TECHNICAL BULLETIN
K192NAS1
07 APR 2014

Service Action: Folding Top Enhancement Program

F-TYPE (X152)

Model Year: 2014
VIN: K00317-K05500

E162496

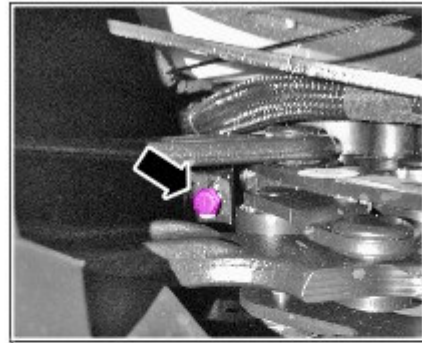
2. Adjust the gap from the folding top to the secondary folding top flap:

- Lift the folding top to the halfway position; make sure the folding top flaps are fully raised.
- Locate the downstop (see fleck of yellow paint) and use an 11mm socket and extension to raise or lower the folding top (clockwise lowers / anti-clockwise raises the folding top).
- Any adjustment should be made in half-turn increments (either way) up to a maximum of two (2) turns.
- Open the folding top and assess the gap from the folding top to the secondary folding top flap. It should be at least 2mm (vertically) and even across the vehicle.

E162497

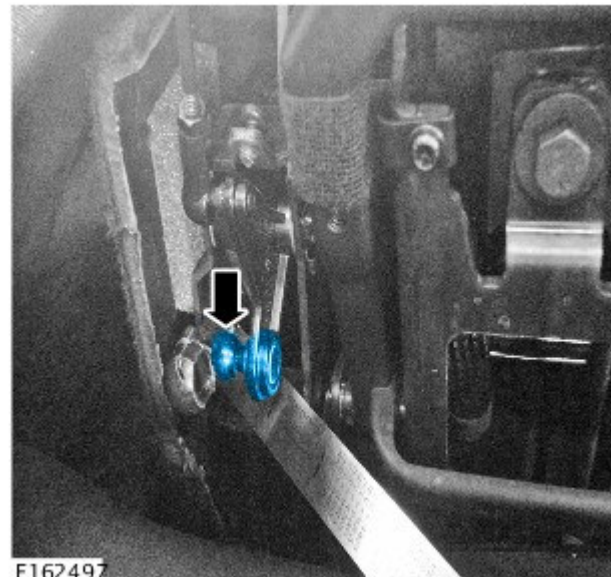
3. If contact is still present, adjust the 'Down lock-to-flaps link rod' one (1) turn (clockwise [inboard] lowers the secondary folding top / anti-clockwise [outboard] raises the secondary folding top flap).

E162498

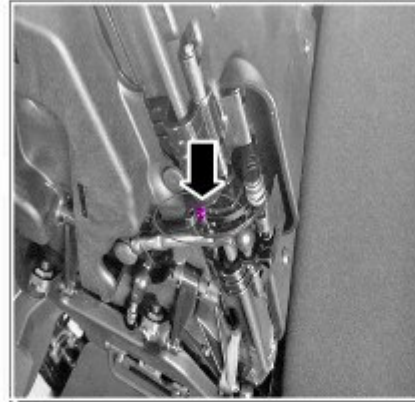
4. Further adjustment can be achieved by turning the secondary folding top flap cap screw clockwise.

E162499

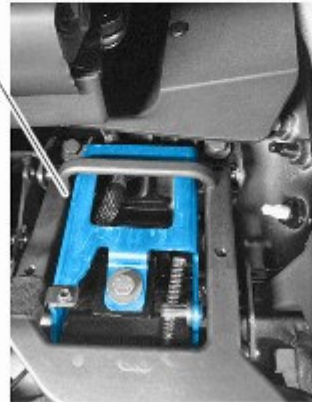
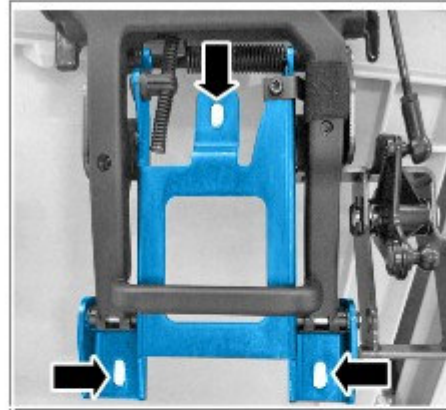
5. In extreme cases, remove the secondary folding top flap assembly mounting bracket, modify the slots to create forward and backward adjustment using a suitable tool.

E162500

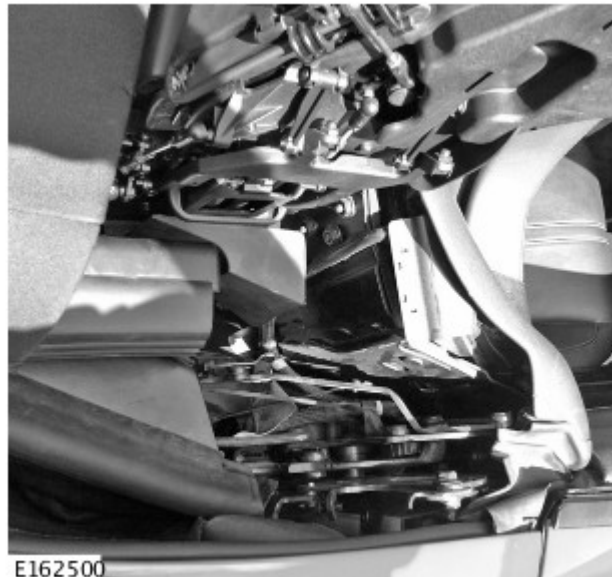
6. With the folding top in the open position, operate the folding top switch until the secondary folding top flaps are in the raised position.
 - Check for wiring harness damage and harness position under both of the folding top flaps.

7.  **NOTE: Right-hand harness shown.**

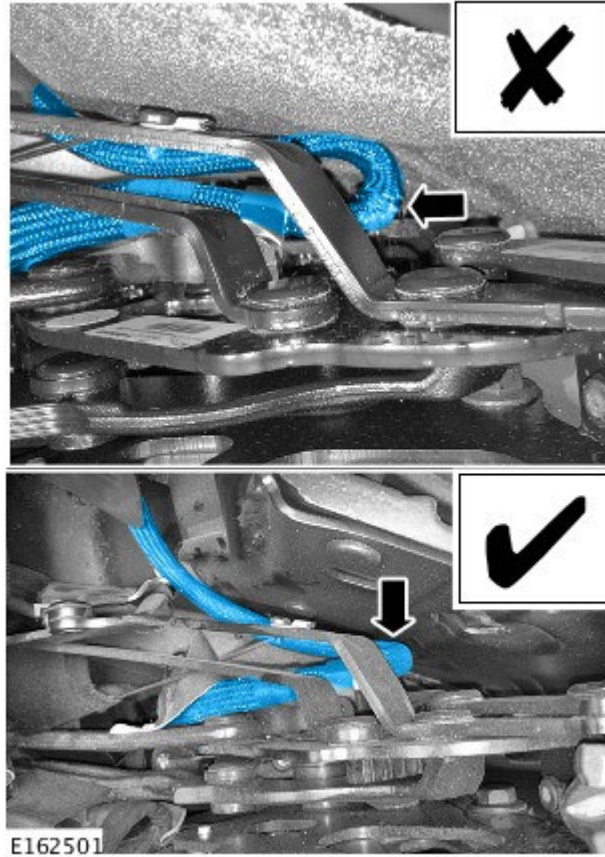
Inspect the right-hand harness; make sure right-hand harness is looped below the link and pulled down rather than trapped horizontally against the foam.

9.  **NOTE: Left-hand harness shown.**

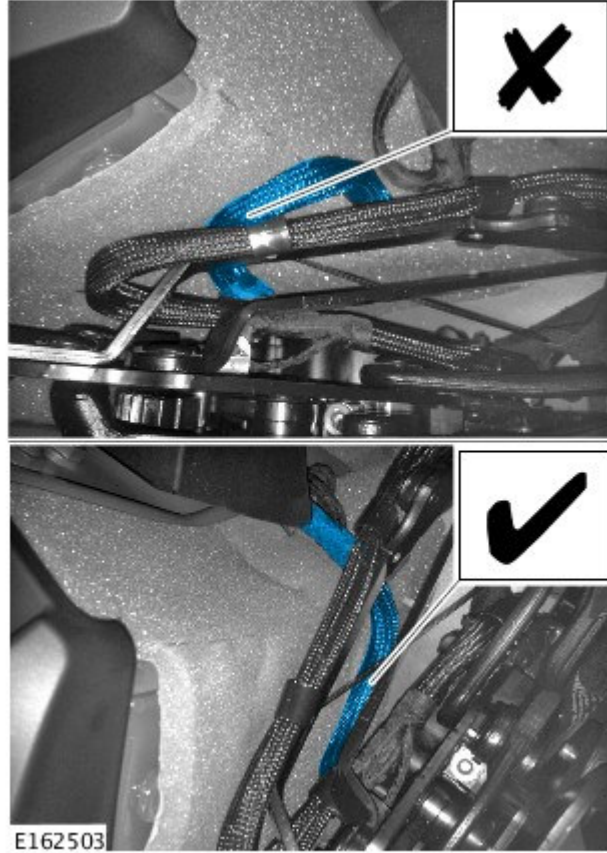
Inspect the left-hand harness; make sure left-hand harness is looped below the link and pulled down rather than trapped between the link and the foam.
